Company	Trenz Electronic GmbH
PCN Number	PCN-20210120a
Title	TE0715-04 DDR3 and Flash Change
Subject	BOM change
Issue Date	(2021-01-20), Revised 2021-03-09

This change affects all Trenz Electronic TE0715 SoMs of revision 04: TE0715-04-*

2.4 #4 Set S/N to not fitted

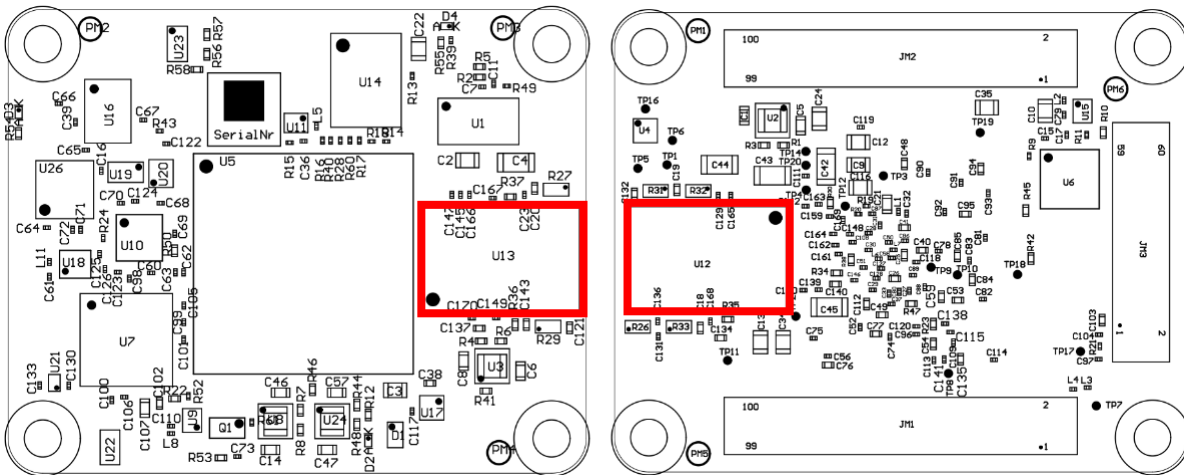
Type: BOM change

Reason: Part is end of life.

Impact: Track it pad no more available.
